ZONING COMMITTEE STAFF REPORT

FILE # 17-206-385

1. **APPLICANT:** Jon Schwartzman - MCR Property Holdings LLC **HEARING DATE:** 1/04/2018
 2. **TYPE OF APPLICATION:** Site Plan Review
 3. **LOCATION:** 1973 - 1977 Marshall Ave, at the NE corner of Moore St. (To be combined as 1975 Marshall Avenue)
 4. **PIN & LEGAL DESCRIPTION:** 332923330021; 332923330022 (Merriams Rearr of Blks 24 29 W 1o Ft of Lot 8 And All of Lot 7 Blk 27, and Merriams Rearr of Blks 24 29 E 4o Ft of Lot 8 Blk 27)
 5. **PLANNING DISTRICT:** 13 – Union Park District Council **PRESENT ZONING:** RM2
 6. **ZONING CODE REFERENCE:** §61.402(c) *Site plan review and approval.*
 7. **STAFF REPORT DATE:** 12/28/2017 **BY:** Tia Anderson
 8. **DATE RECEIVED:** 10/18/2017 **DEADLINE FOR ACTION:** 2/15/2018 (Extension Letter sent)
-

- A. **PURPOSE:** Site Plan Review for a new five-story, 16 unit apartment building with 30 structured parking spaces.
- B. **PARCEL SIZE:** 14,171 square feet, plus 998 square feet for half the alley (approx. 0.35 acres)
- C. **EXISTING LAND USE:** 1973 Marshall – one-family dwelling, 1977 Marshall – duplex
- D. **SURROUNDING LAND USE:**
North: One-, two- and multiple-family residential, ins

DEMOLITION
PLAN

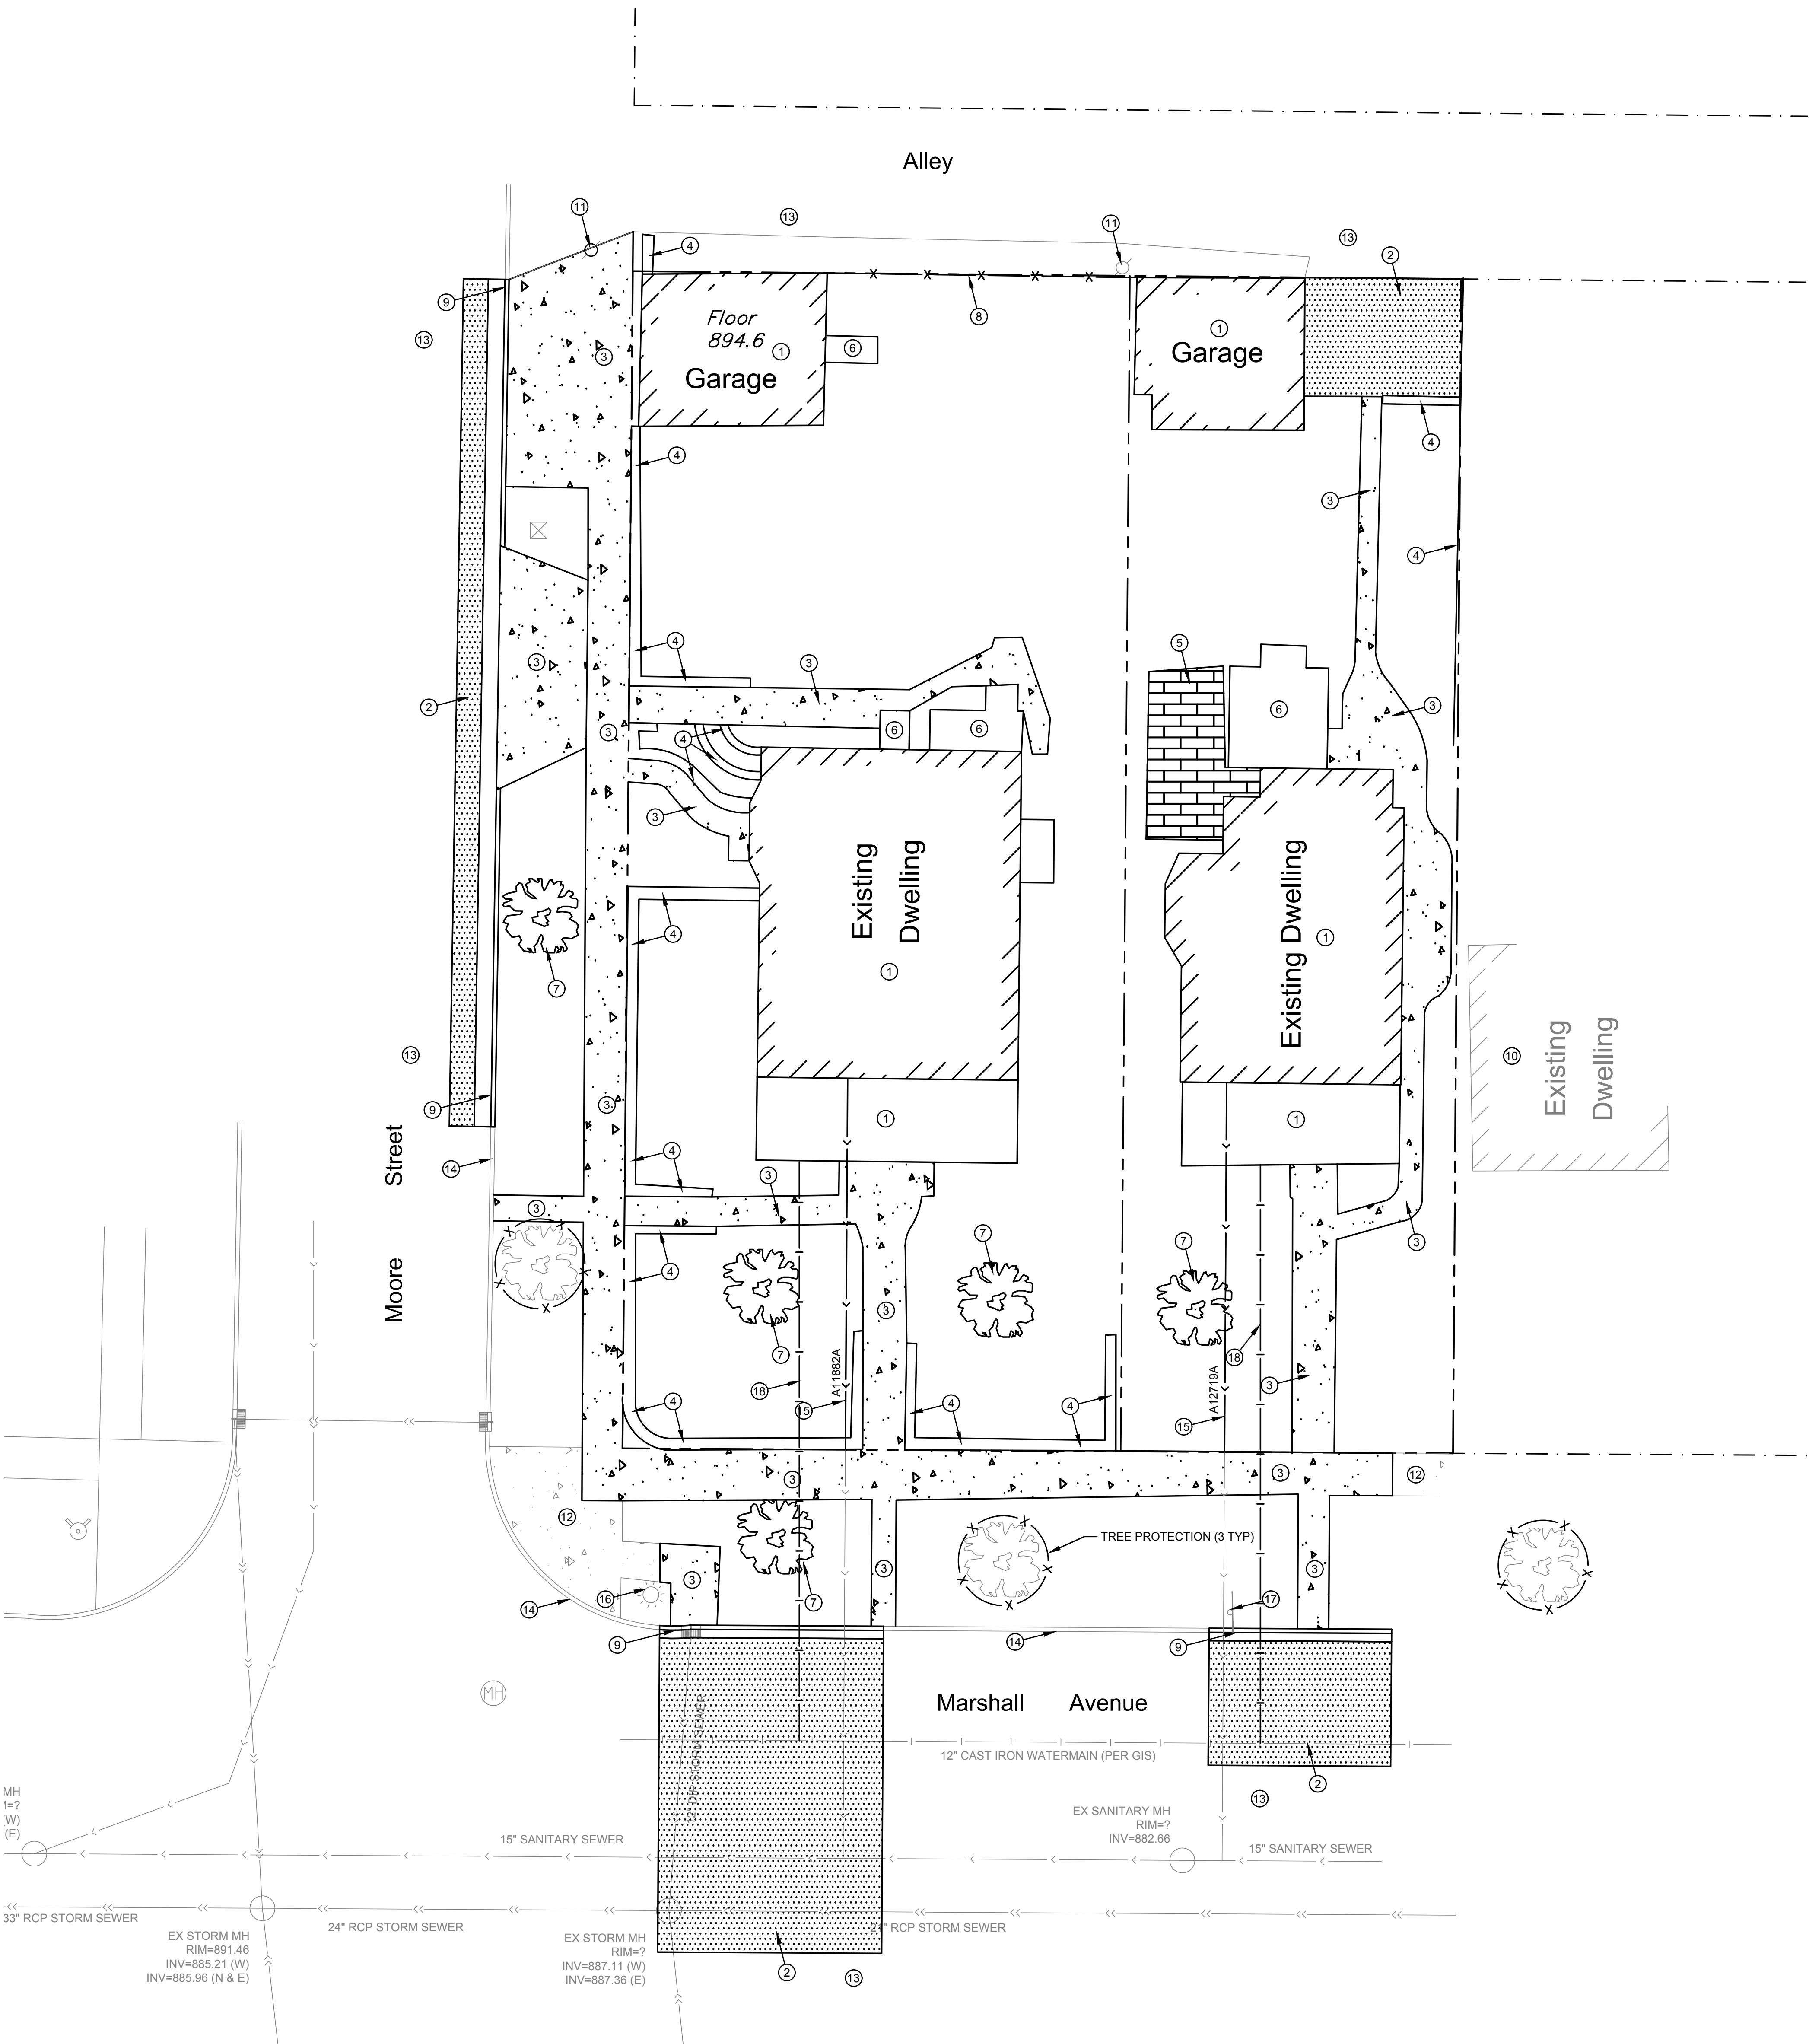
- d) On Plan Sheet C1 please include notes regarding the protection of, or impacts to, the existing boulevard infrastructure such as street lighting, signs, etc.

Response: See "Demolition Note" #10 on sheet C1

PAVING AND LANDSCAPING PLAN

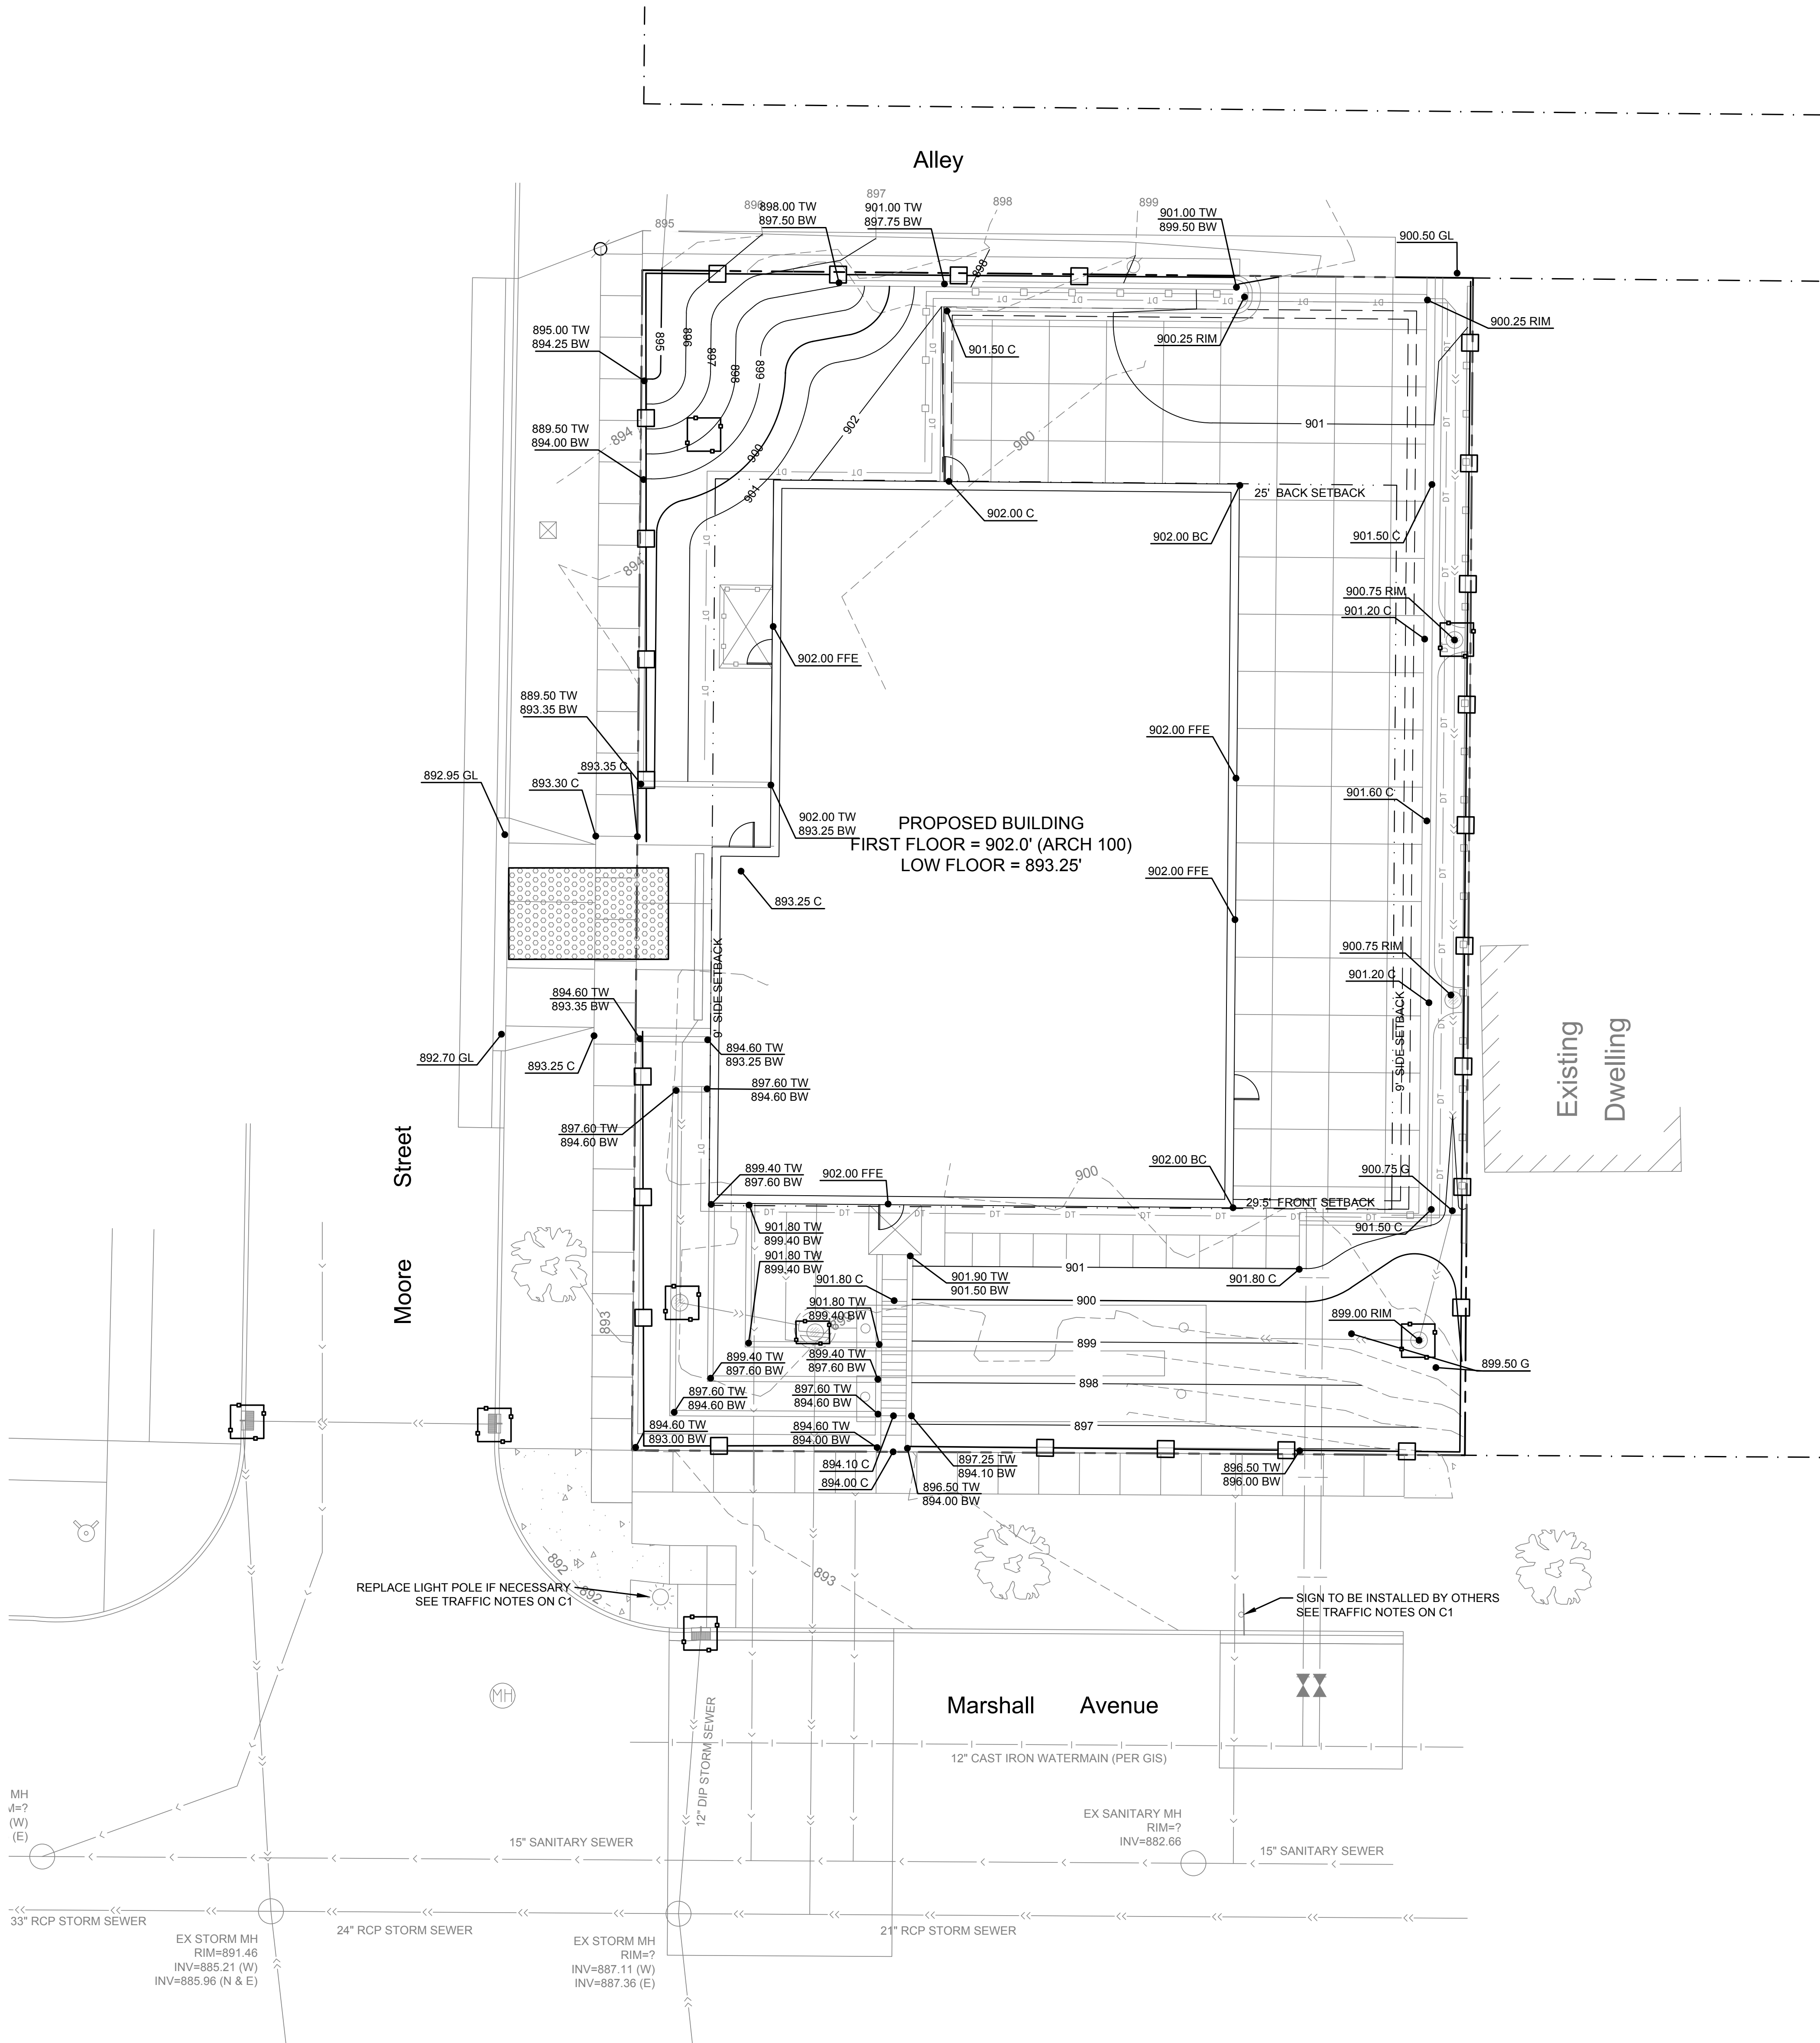
- e) Please provide turning templates relative to accessing and exiting the proposed three stall garage, the two on-grade stalls and the two stalls in the garage as shown on Plan Sheet C2.

- f) Please provide detailed dimensions to Plan Sheet C2. The width dimension of the driveway at the ROW line is to be 22 feet unless turning movements indicate something wider is needed.

Response: See updated Sheet C2.
